Okanogan County

Addendum No. 1

CRP No. 9155-20 Old 97 , Verestar to Plata

ADDENDUM 1
CRP No. 9155-20
Old 97 Verestar to Plata
TYPICAL SECTIONS

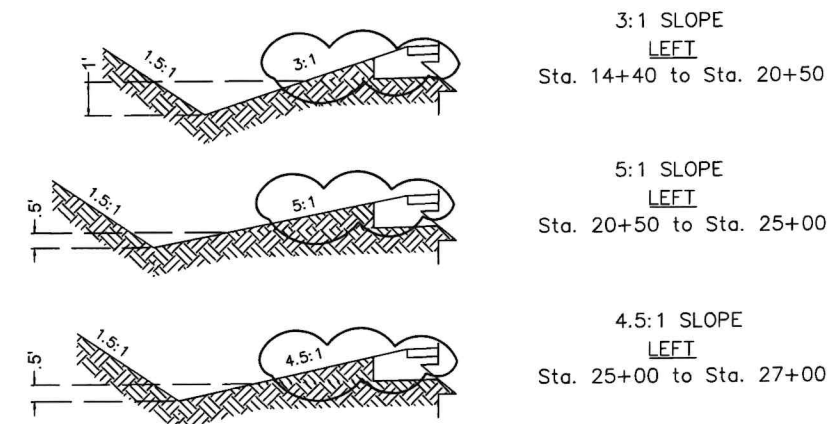
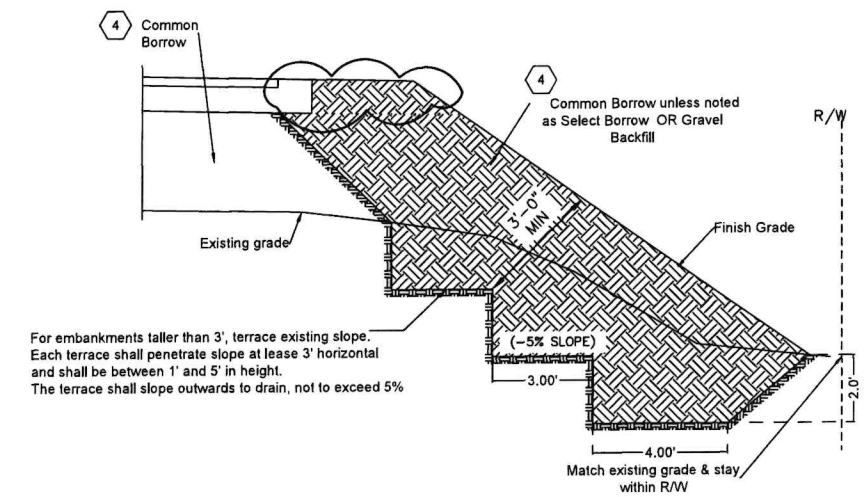
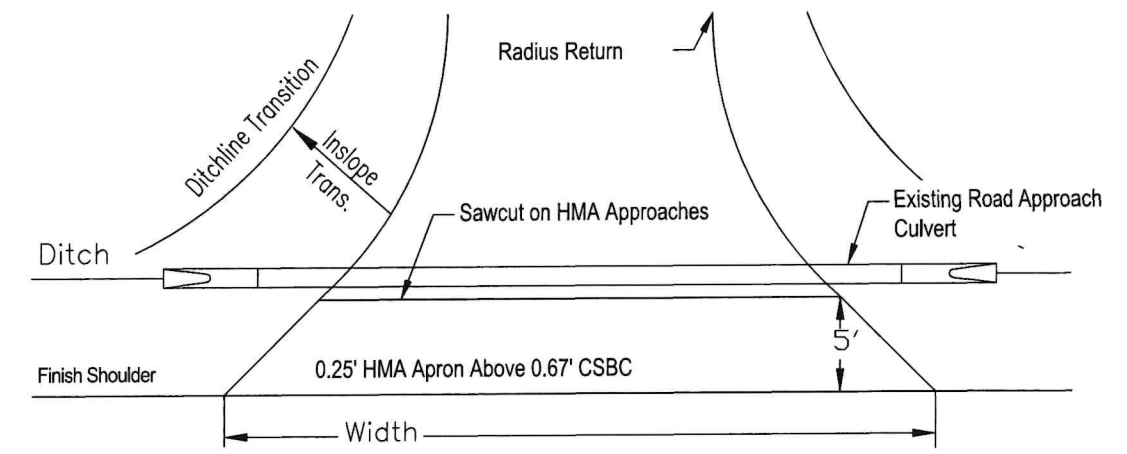
2. Plan Sheets 5, 6, 7, 8, and 9 have updates for the vault locations for fiber optic lines and line work regarding extents of CSBC and are replaced with attached.
